Service Manual

27037A/B

22AP140/15 00001 up to 10001
22AP140/18 0001 up to 1001

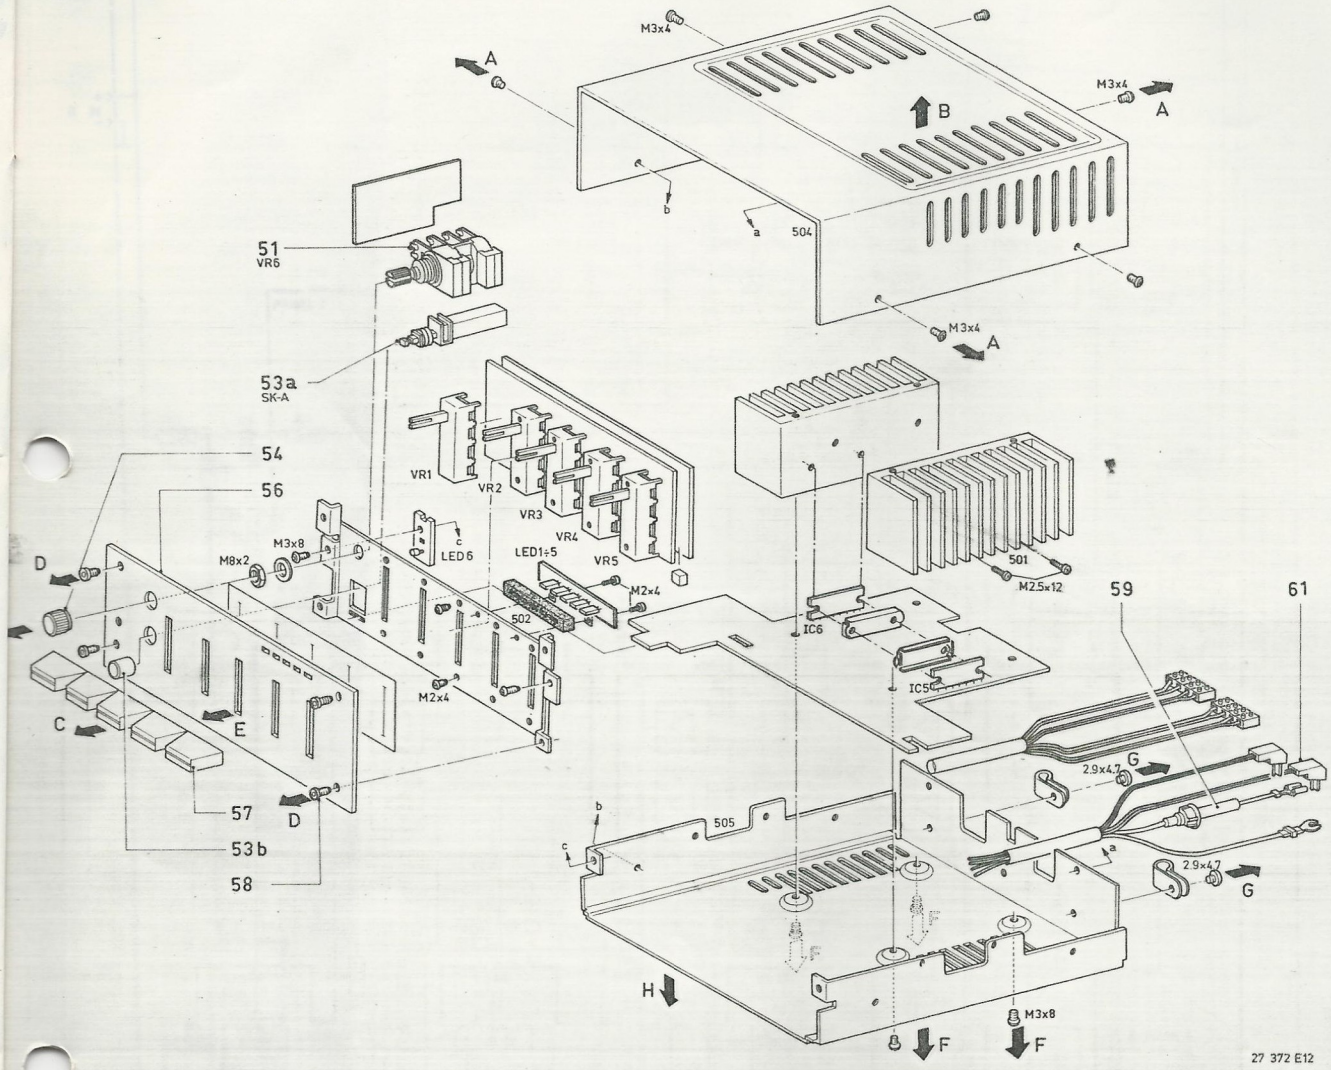
In production apparatus with serial number

the following changes should be applied:

- C30, 34, 41 and 45 (47 nF) to be changed to 10 nF mylar (4822 121 41474).
  Reason of change:
  To improve stability.
- The two red leads, labelled (!) in the circuit diagrams, should be interrupted and then connected crosswise.
  After this, the leads should be insulated.
  Reason of change:
  The speaker signals are in phase opposition when the booster is switched on/off.
